Cross River Rail Environmental Impact Statement

Request for Project Change 11

Changes to the Project and changes to the
Imposed Conditions – Clapham Yard

Response to Submissions Report

Figure 2: Brisbane River, Moolabin Creek, Rocky Waterholes and Oxley Creek/Stable Swamp Creeks and catchments

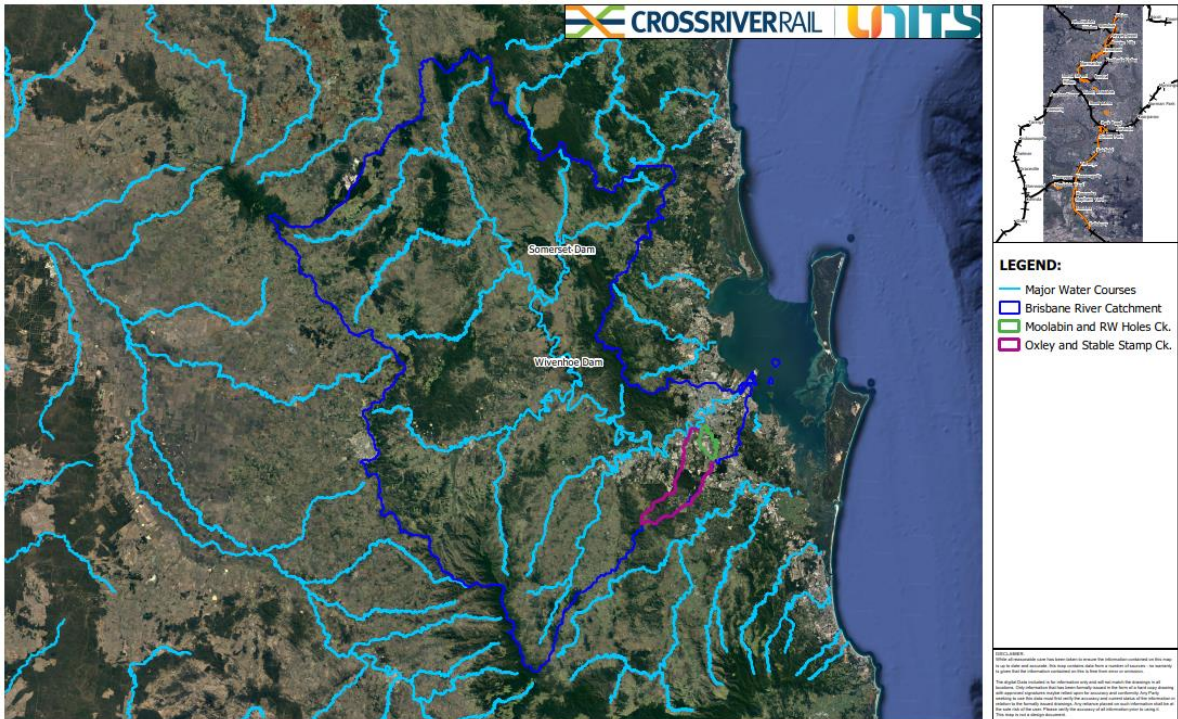
A number of submitters raised concerns about the increased potential for flooding impacts upstream/downstream of Clapham adjacent to Moolabin Creek as a result of raising the stabling yard facility to achieve a level of flood immunity for QR infrastructure.

The local government stated that an assessment of flood events greater than 1% AEP should be conducted to demonstrate built infrastructure does not substantially increase flood risks for extreme events.

Figures 2 and 3 shows the comparative size of the Brisbane River catchment, 1% AEP flood extent and the Clapham Yard filling, clearly demonstrating the limited potential of the works to change the Brisbane River flood dynamics.

- Brisbane River dominant flood mechanism
- Local creek flood levels (Moolabin/Rocky Waterholes) significantly lower (2m -3m)
- Flooding at Clapham Yard within this area is storage driven with consistent flood levels across a large area (low/no hydraulic grade).
- Brisbane River floodwaters at Clapham Yard tend to be slow moving.

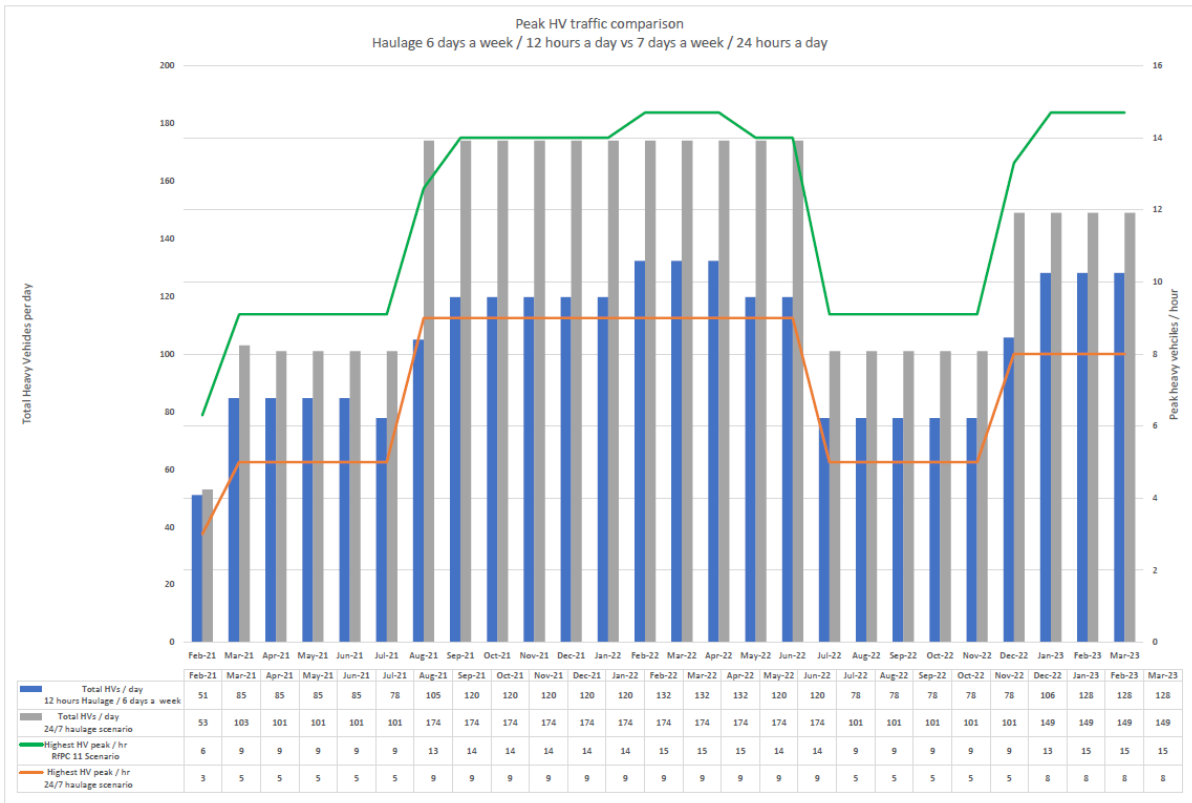
3. The application states “This RFPC also proposed to change Imposed Condition 10 to ultimately enable 24/7 haulage, which will decrease peak heavy vehicle traffic and allow vehicle movements to be more evenly spread across the day, therefore further reducing residual impacts on effected intersections”
 - a. Please provide the relevant figures to support OCG making the following conclusion – Currently there is a maximum of XX heavy vehicles accessing Clapham Yard per hour. With 24/7 haulage proposed by RFPC 11, this will reduce to XX heavy vehicles per hour on average as total vehicle movements will be more evenly spread across a longer timeframe”.

Currently there is a maximum of **15** heavy vehicles accessing Clapham Yard per hour if haulage is allowed to occur 6 days a week / 12 hours a day. With 24/7 haulage proposed by RFPC 11, this will reduce to **9** heavy vehicles per hour (as a maximum) as total vehicle movements will be more evenly spread across a longer timeframe”.
 During the morning and afternoon peak hour traffic periods this will reduce the maximum number of heavy vehicles from **8** heavy vehicles to **3** heavy vehicles (1 HV every 20 minutes)
